BWROG HUMAN FACTORS ENGINEERING - CONTROL ROOM SURVEY SUPPLEMENT

In response to recently formulated regulatory requirements for design reviews of nuclear power plant control rooms (NUREG-0660, NUREG-0700), Cleveland Electric Illuminating Company has undertaken a preliminary human factors evaluation of the Perry control panels. This one week review was performed by operations and engineering personnel from three utilities, two human factors consultants, and a representative from General Electric Company. General conclusions of the survey team are as follows:

PHOTO #6

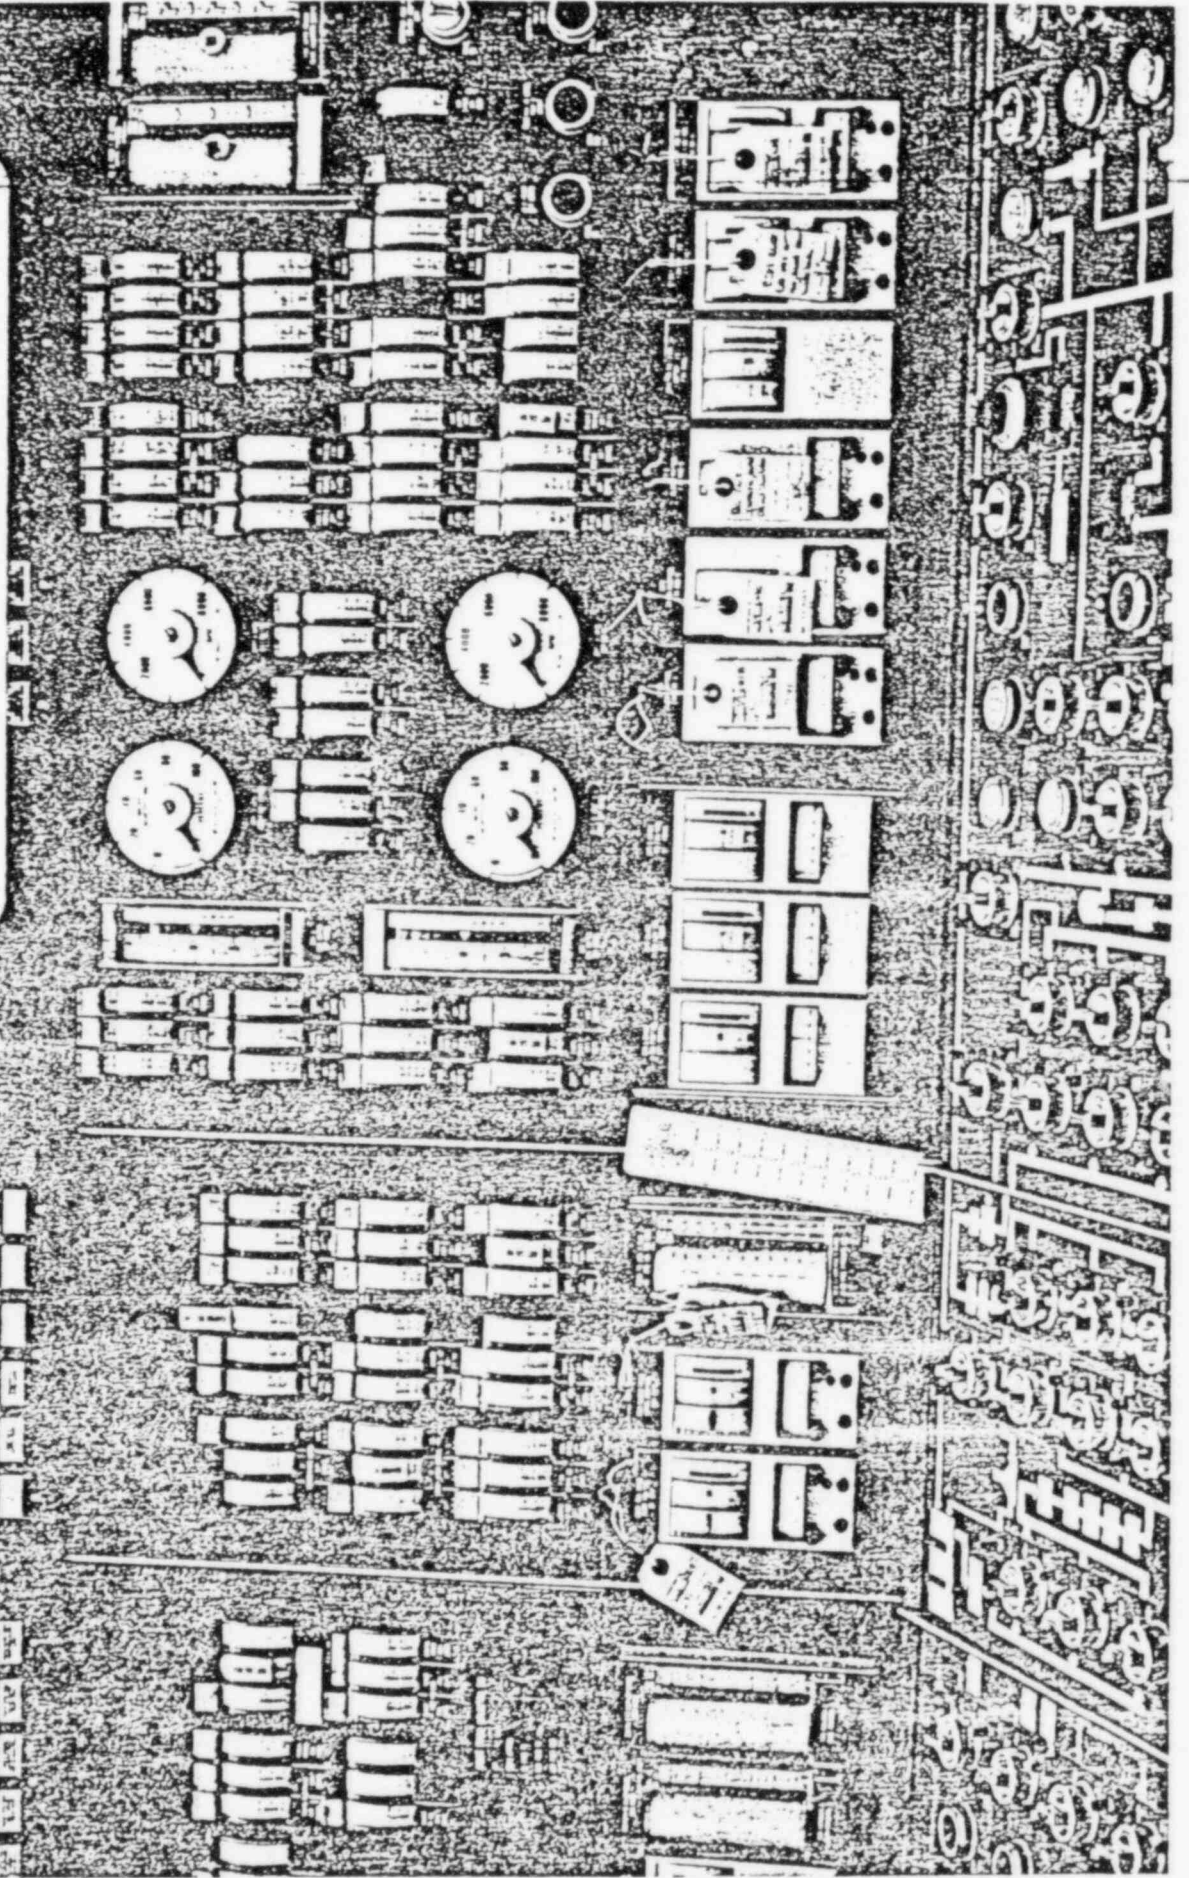
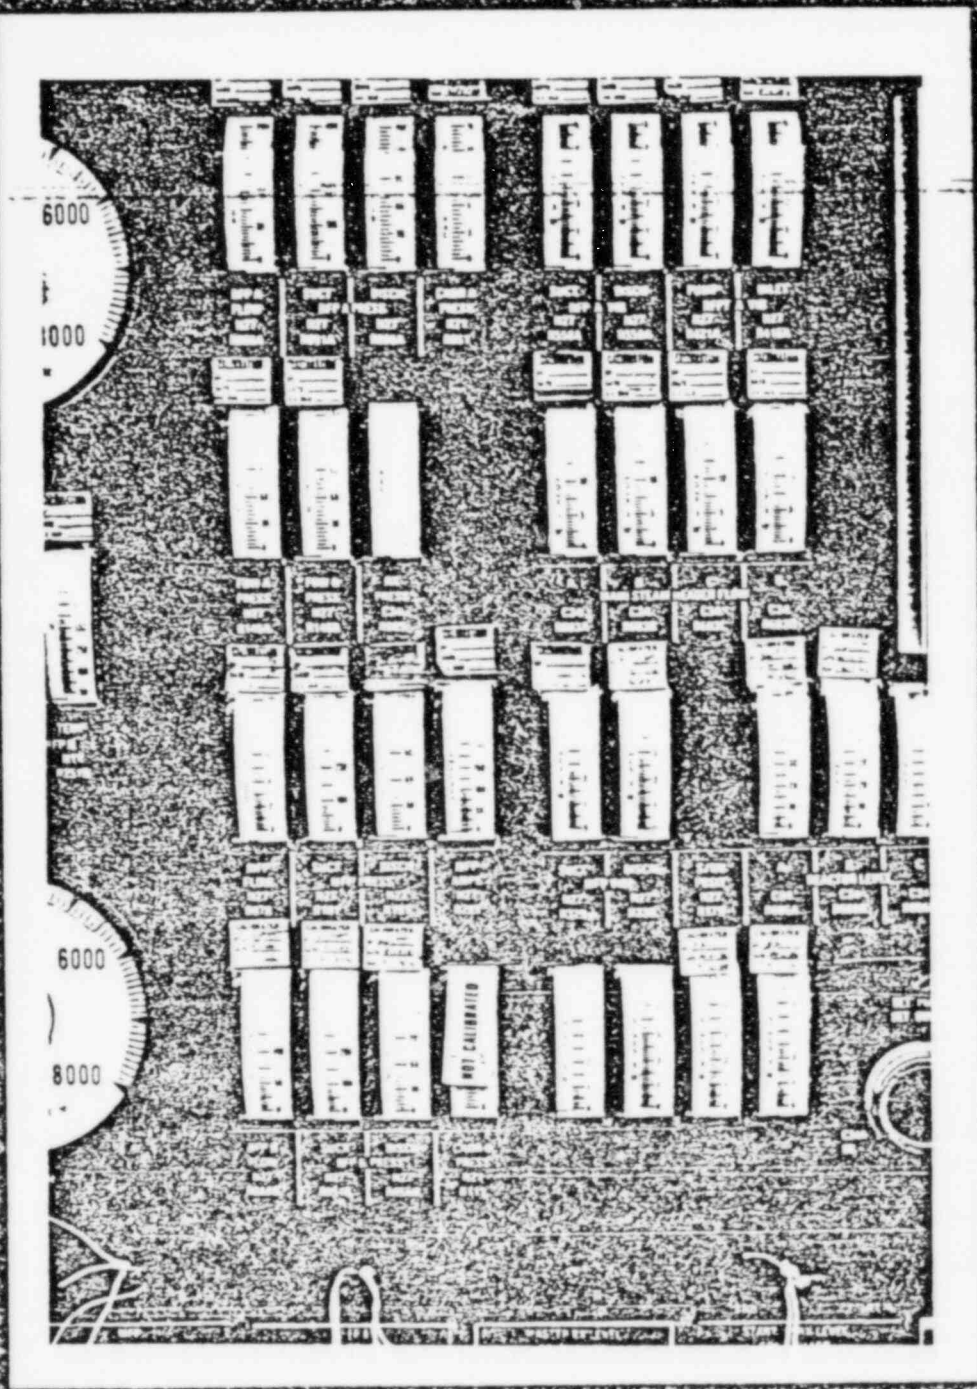
A closeup of instrumentation on panel 680. Note the four indicators at lower right without labels. One label has no associated indicator (N27-R179). Reactor pressure indicator C34-R605 has no scale.

PHOTO #7

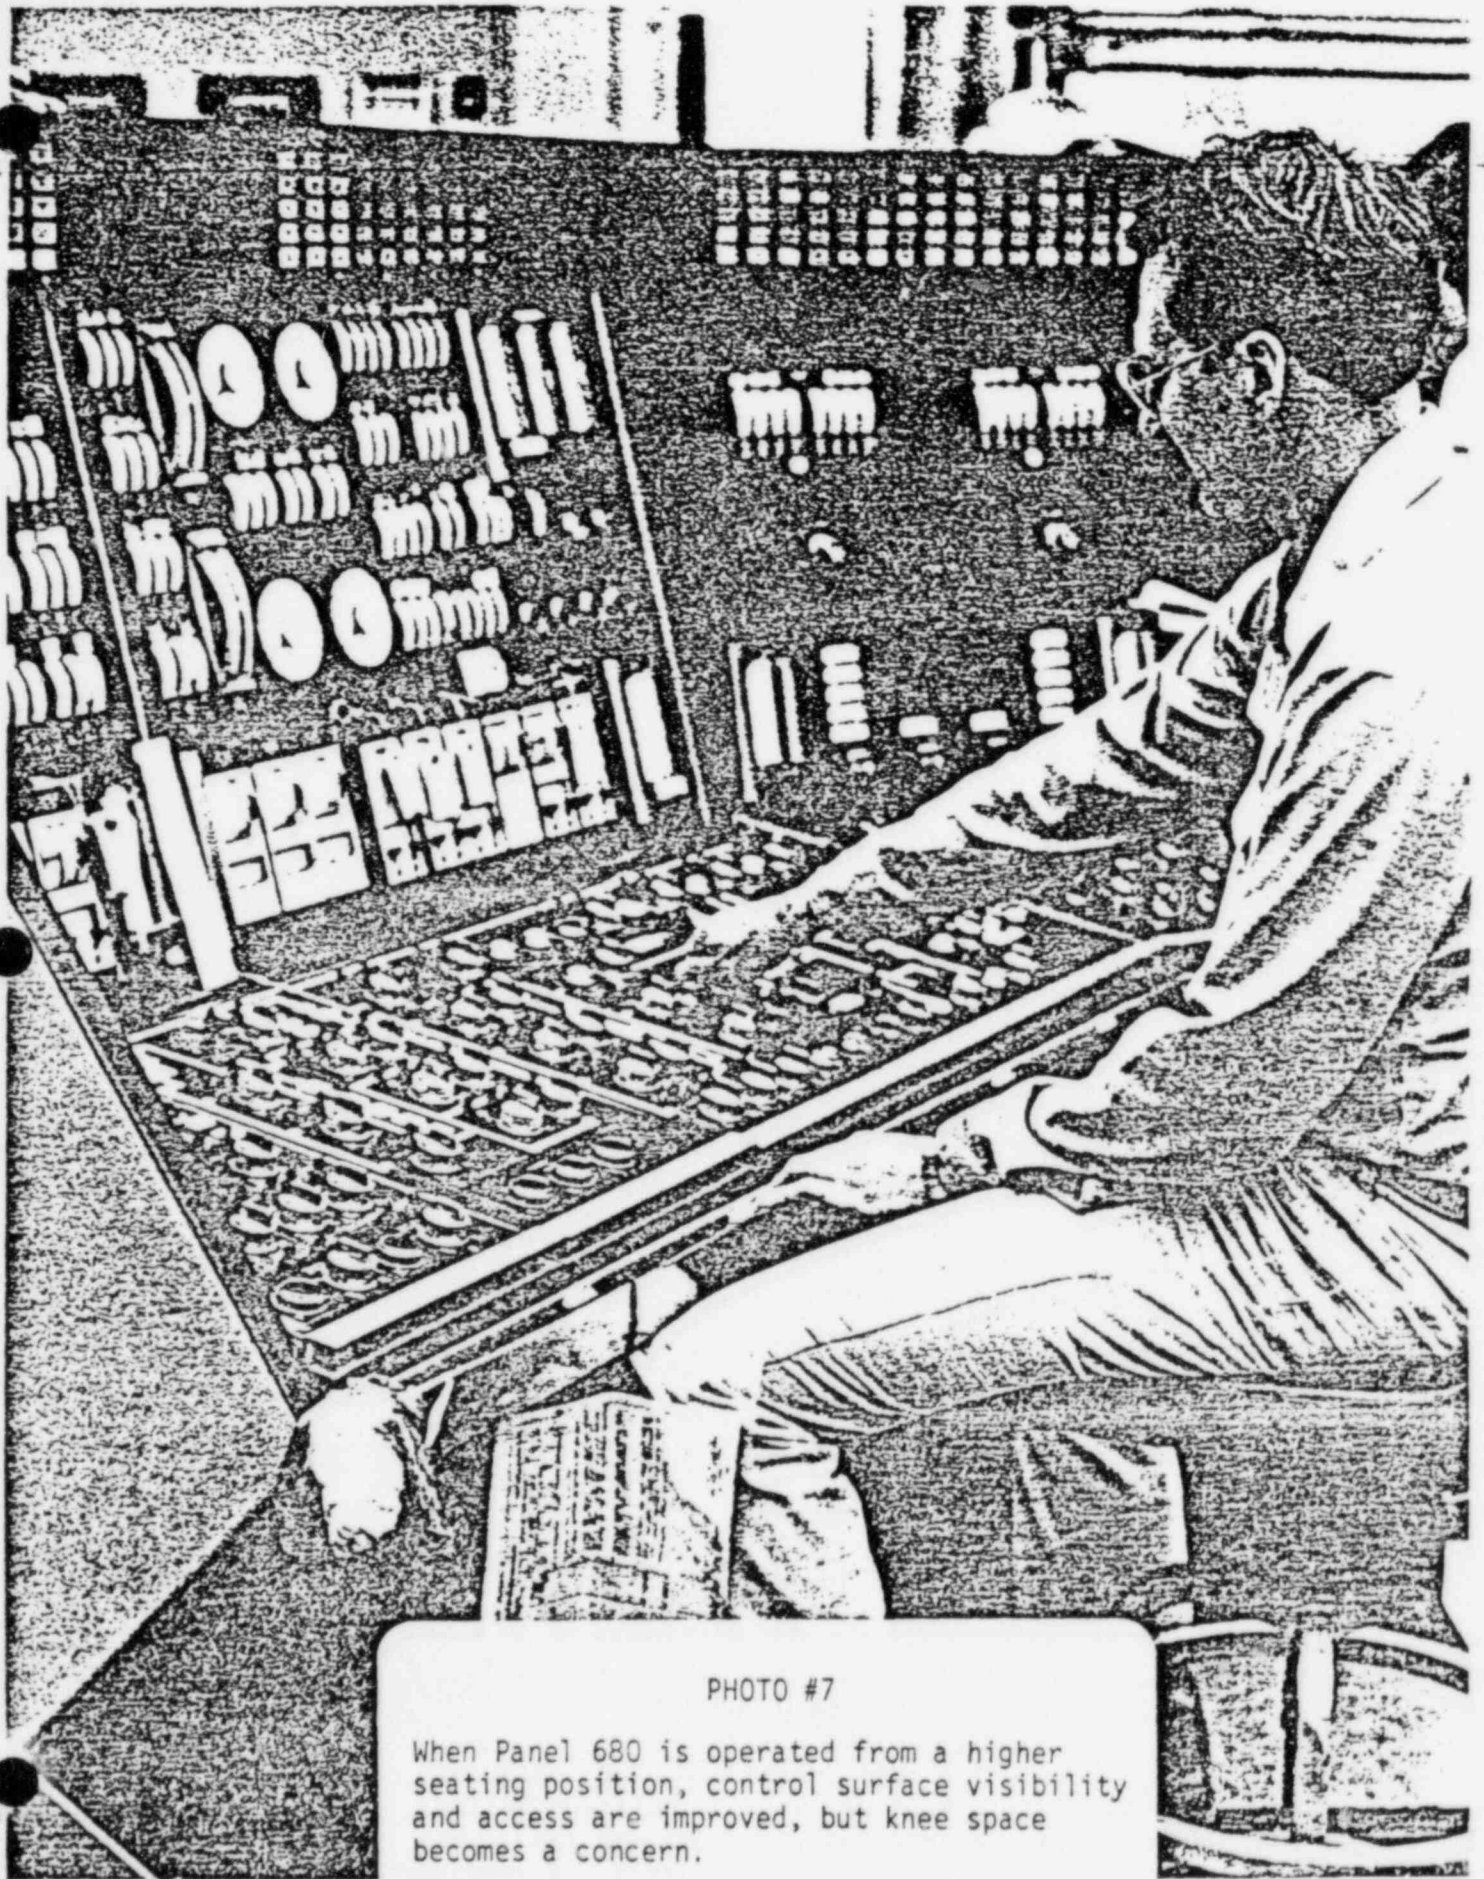
When Panel 680 is operated from a higher seating position, control surface visibility and access are improved, but knee space becomes a concern.

PHOTO #8

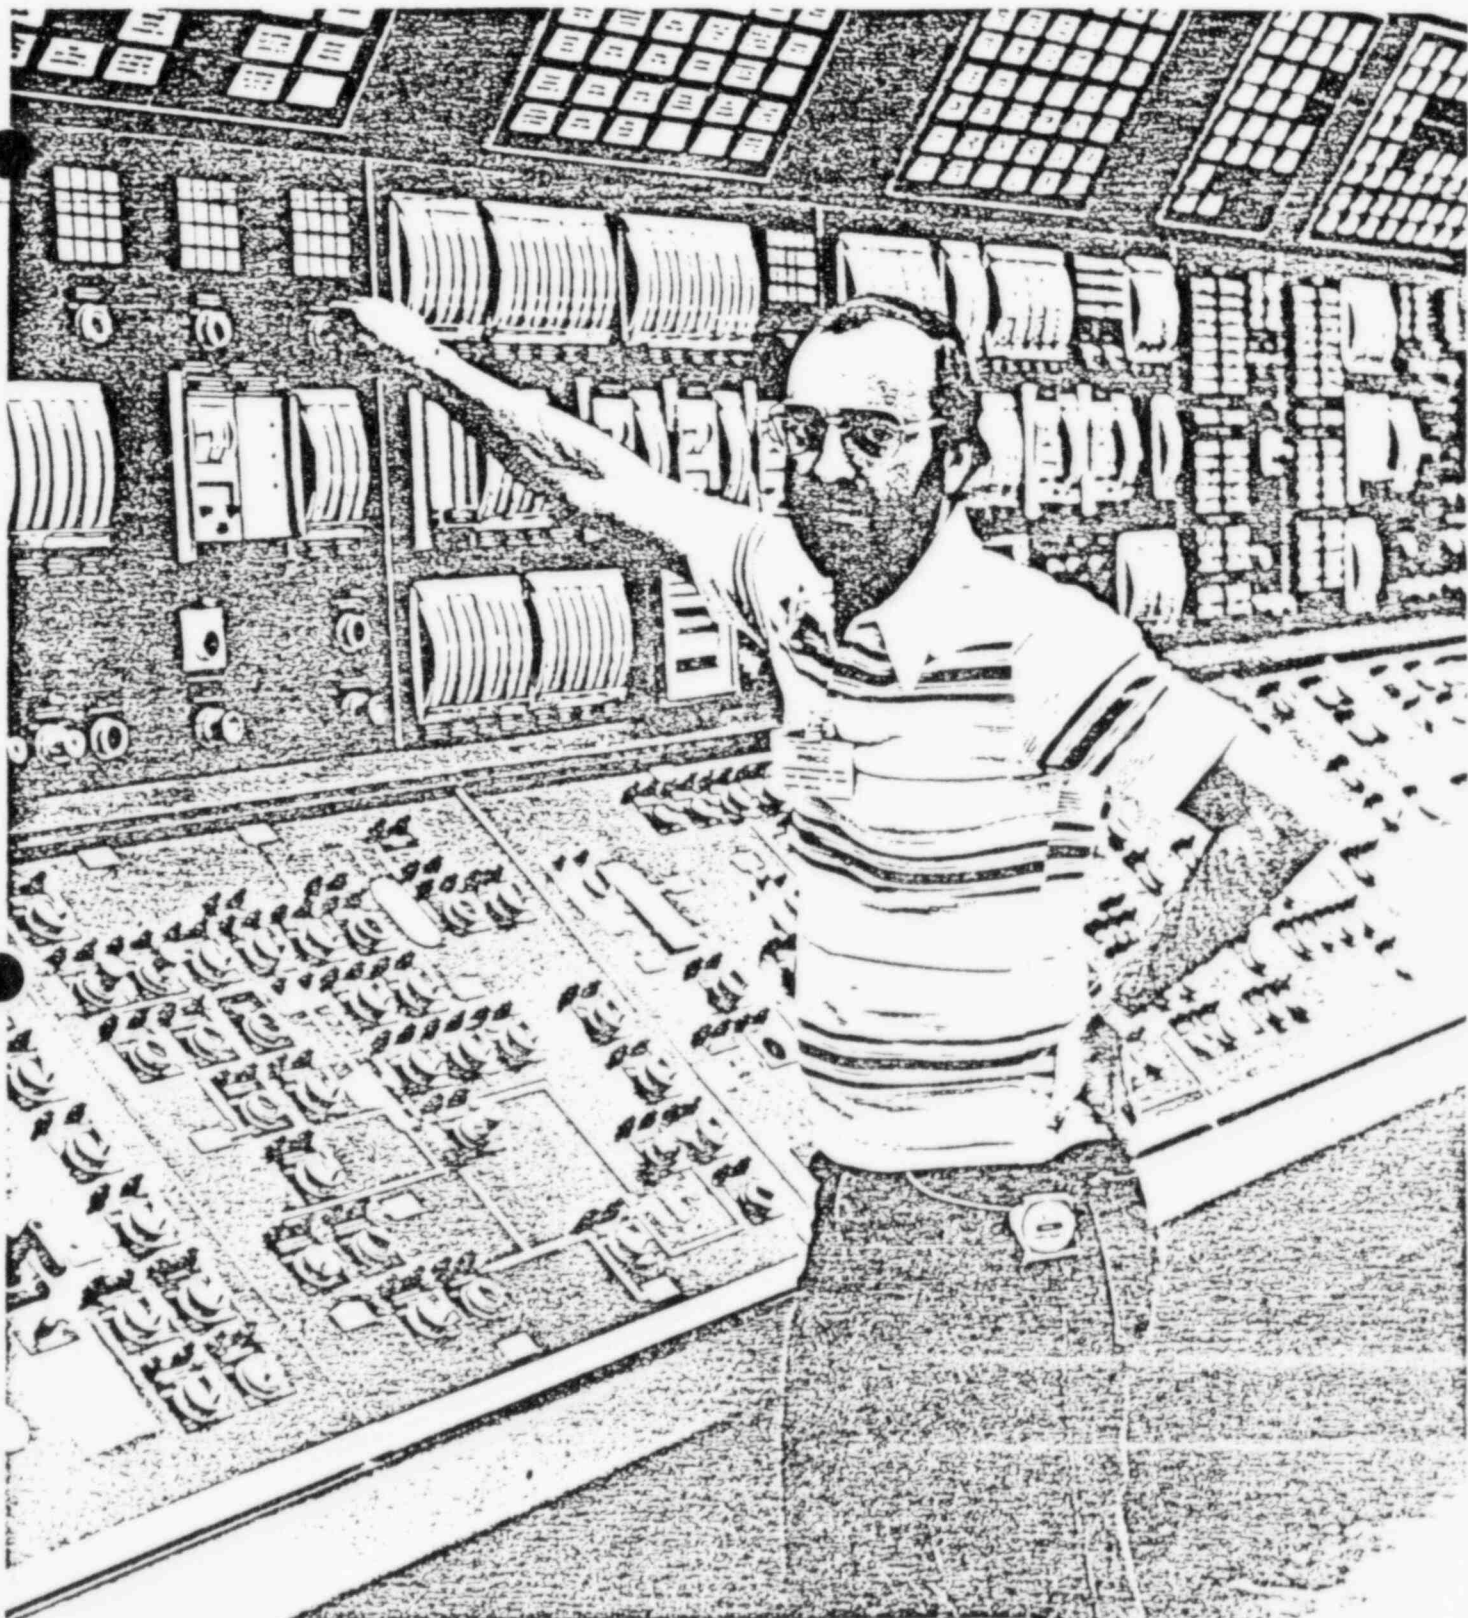
The top row of indicators and the out-of-service switches on Panels 601 and 870 are mounted above recommended heights.

PHOTO #13

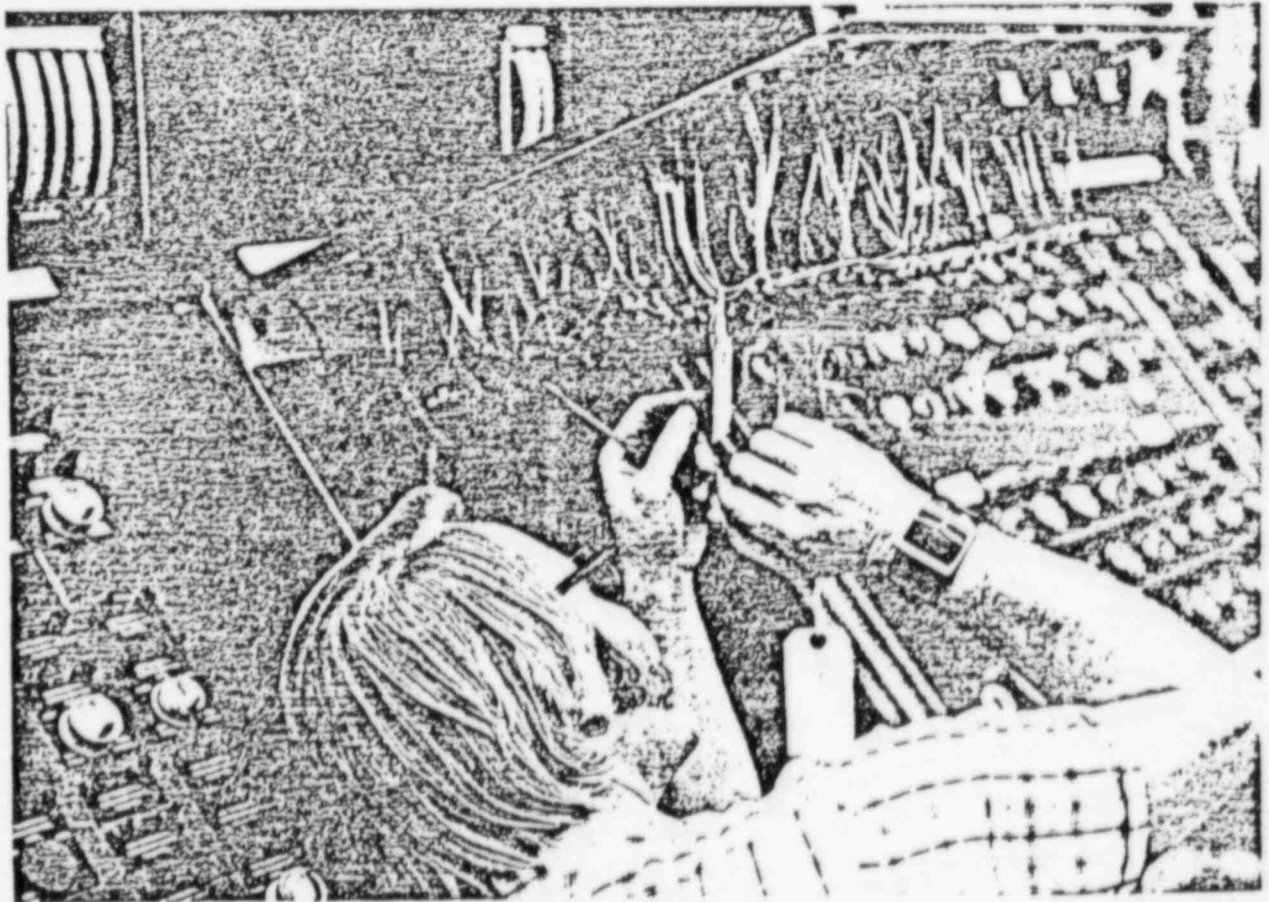
Functional demarcation techniques have generally not been applied to quantitative displays on the "B" inserts of control benchboards.
